Shoalhaven Starches 36 Bolong Road Bomaderry NSW 2541

**Subject: Assessment of the Gluten Dryer 8 Modifications**

Pinnacle Risk Management Pty Limited, Revised Preliminary Hazard Analysis, Modification Application to Mp06-0228 Mod 16 & 17, Shoalhaven Starches Expansion Project, Proposed New Specialty Processing Facility, New Gluten Dryer and Other Associated Works at 22, 24 And 171 Bolong Road, Bomaderry, NSW, 28 July 2020.

**Attachment 1 - Layout Drawing Showing the Proposed Changes**

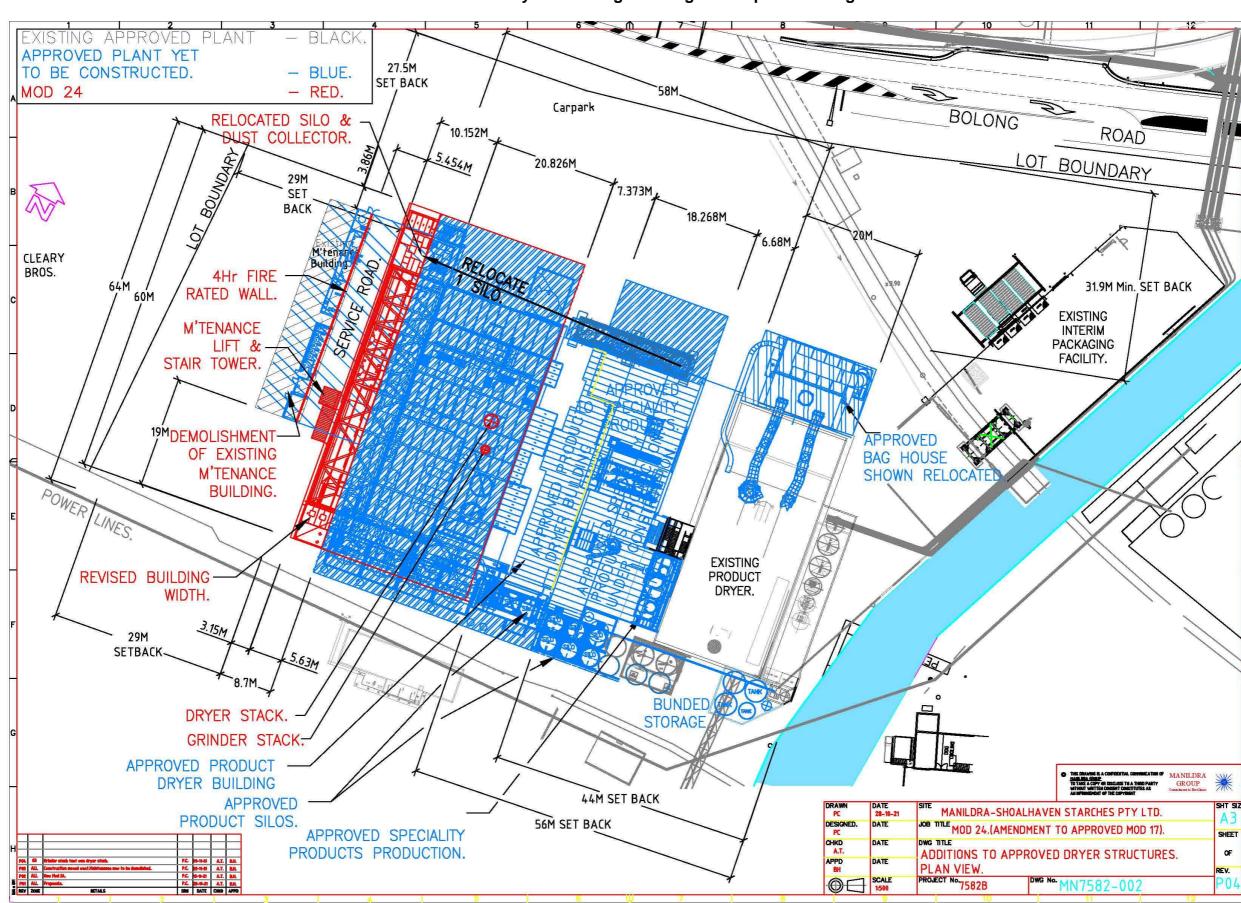
- The GD8 building needs to be fire separated from the Specialty Product Building. Under Mod 17, the GD8 building adjoined the Specialty Products Building. It is now proposed to set the GD8 Building 6 metres from the Specialty Product Building to provide sufficient fire separation under the BCA. This in effect shifts the building to the west. The separation of these buildings will also provide the benefit of allowing operational access to remove / install equipment for maintenance purposes;

- The internal dimensions of the building are proposed to be amended to accommodate paths of travel within the building to comply with the BCA, as well as improve operational manoeuvrability;

- Provide a stair tower adjacent to the western wall of the relocated GD8 building to provide compliant paths of travel under the BCA which has further added to the footprint of the proposal;

- To accommodate the shifting of the GD8 building footprint to the west, it is now proposed to demolish the Maintenance Building which the GD8 building was to originally adjoin under Mod 17; and

- The roof of the GD8 building has also been raised to provide a skillion roof to improve stormwater design to better meet BCA requirements.

- The overall process safety risk from the GD8 is the same as per the abovementioned PHA;
- The hazardous plant operation and safeguarding in the PHA remain unchanged; and
- The conclusions in the PHA are therefore unchanged, i.e. the proposed changes will still result in compliance with the DoP's risk criteria in HIPAP No. 4;

It is, of course, possible to update the PHA, however, the conclusions will not change.
